**Technical Service  
BULLETIN**

**EXCESSIVE SULFUR DIOXIDE ODOR**

'02 – '04 Solara (2AZ-FE)

ENGINE  
EG014-04

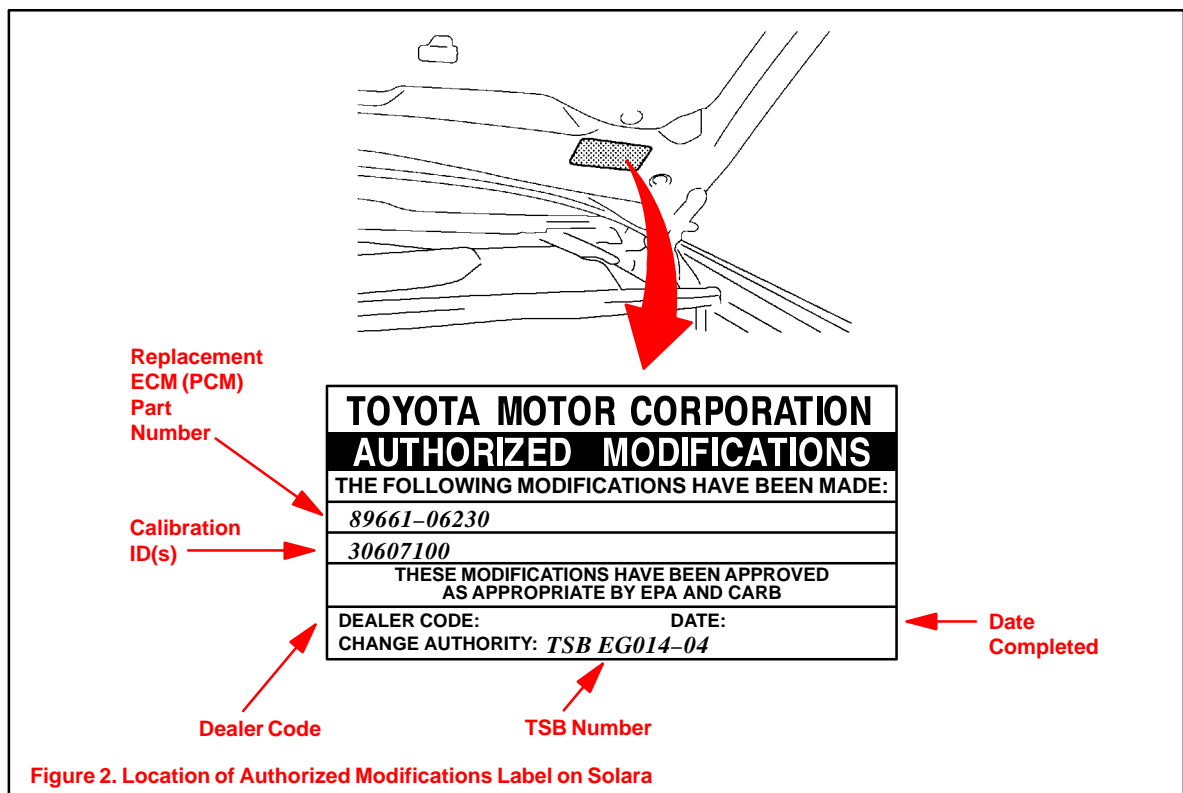
1. Check for the Authorized Modification Label affixed to the vehicle in the location shown in Figure 2 on page 4. If there is no label present, proceed to step 2.
2. Connect the Diagnostic Tester to the vehicle and select “CURRENT ECU CAL” from the “ECU REPROGRAM MAIN MENU.” To determine the vehicle’s current ECM (PCM) calibration, see Figure 1 below.

4. Select the proper ECM (PCM) calibration file for the model year vehicle and reprogram the ECM (PCM).
5. Start the engine and warm up the vehicle to normal operating temperatures before test driving.
